POLICY REPORT
DEVELOPMENT AND BUILDING

TO: Vancouver City Council
FROM: General Manager of Planning and Development Services
SUBJECT: CD-1 Rezoning: 4949-5109 Cambie Street

**4949-5109 Cambie Street
PROPOSED CONDITIONS OF APPROVAL**

Figure 2: Site Plan

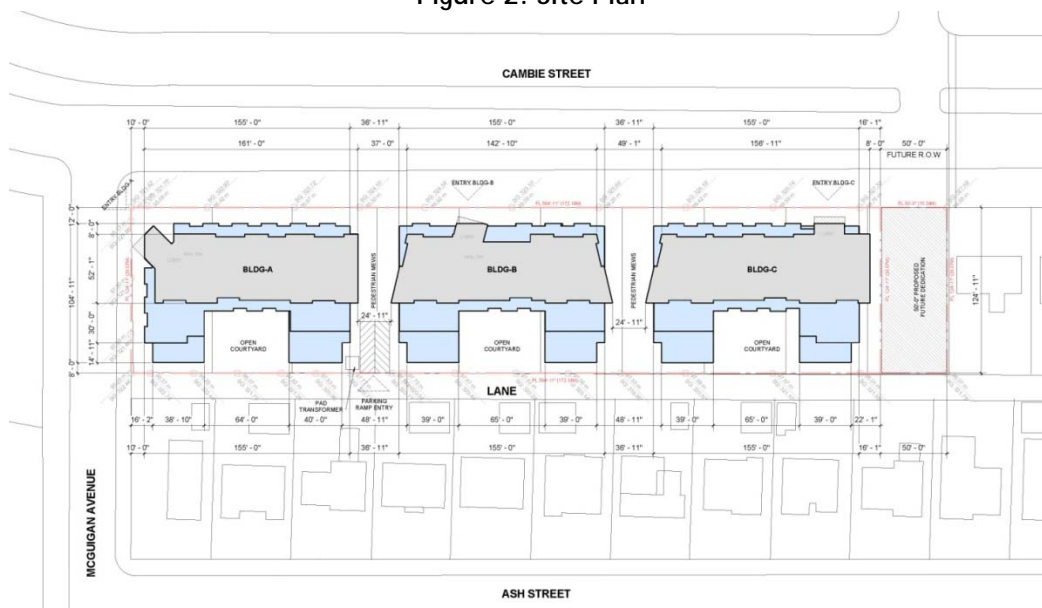
- 1. Design development to create an active, green, and pedestrian-oriented lane edge, minimizing the appearance and extent of service-oriented spaces such as ramps, garbage areas and transformers.

Note to Applicant: In particular, the extensive ramps that zigzag through the courtyard spaces should be replaced by internal paths or elevator access to reconcile the grade changes on the site. More substantial planting and larger species should be chosen to benefit both future residents and create a screen between the new six-storey building and existing neighbours to the west.

- 2. Design development to vary the parapet or skyline profile of the main building masses along Cambie Street, especially from one block to another.

- 3. Design development to the exterior colour and materials palette to reduce the apparent visual mass of the uppermost floors, to bring more visual interest and brightness to the building, and to better reflect the structure of the form.

- 4. Design development to the vertically oriented block forms facing Cambie Street to work better with the living spaces inside.

5. Provision of a substantially sized row of trees on the Cambie Street, McGuigan Avenue, and future road frontages.
